**Invitation for Bid No. 2025-009**

**Crooked Creek WRF Fence Replacement**

**ADDENDUM No. 1**

**ISSUE DATE: November 22, 2024**

# CROOKED CREEK WRF FENCE

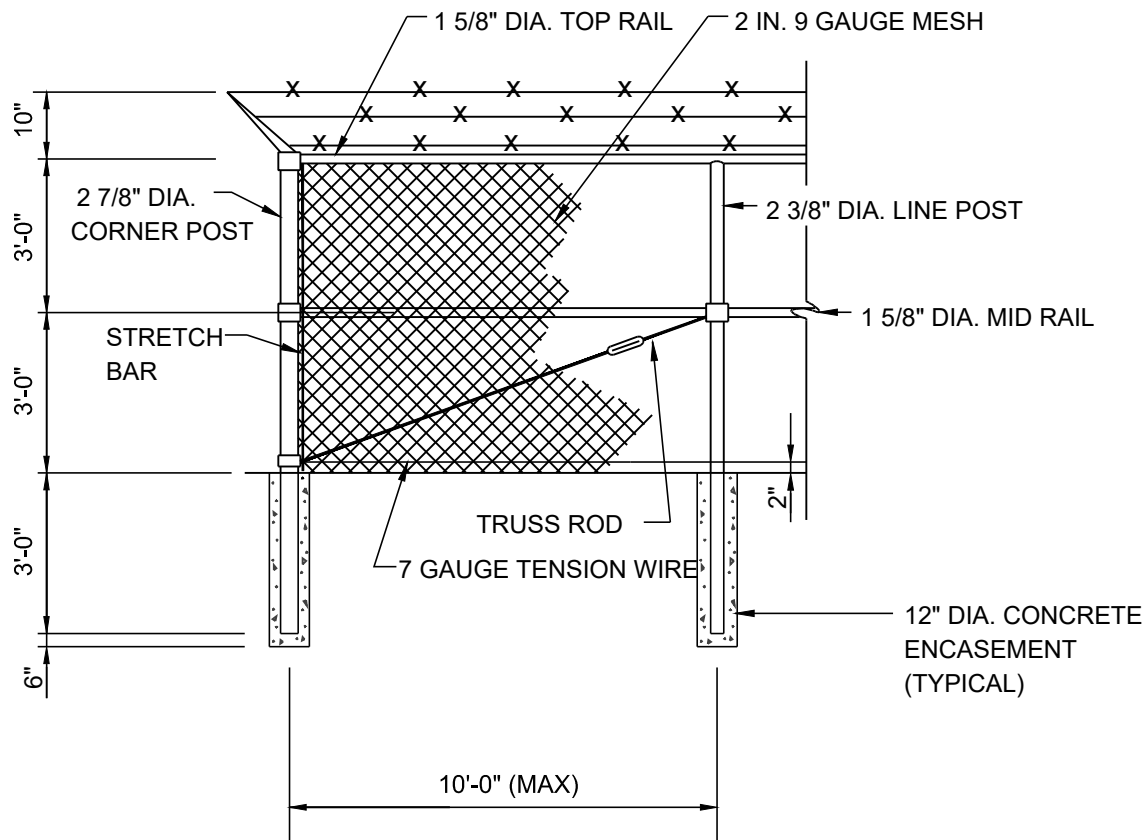
1. **Add:** Appendix G – Union County Water Crooked Creek WRF Fence Drawing Crooked Creek WRF Fence Drawing is attached.
2. **Delete:** Approximately 780' throughout the document  
**Replace with:** Approximately 475' throughout the document
3. **Delete:**  
Due Date: **December 3, 2024, at 2:00 PM** throughout the document  
**Replace with:**  
Due Date: **December 10, 2024, at 10:00 AM** throughout the document
4. **Delete:**  
Appendix A- Price Form  
**Replace with:**  
Appendix A – Addendum #1 Price Form

12. **Question:** Yesterday we were told that the fence just needs a top rail with tension wire on the bottom (no mid rail or bottom rail). Can you confirm?

**Answer:** We want a top and mid-rail.

Refer to section A) Item #1.
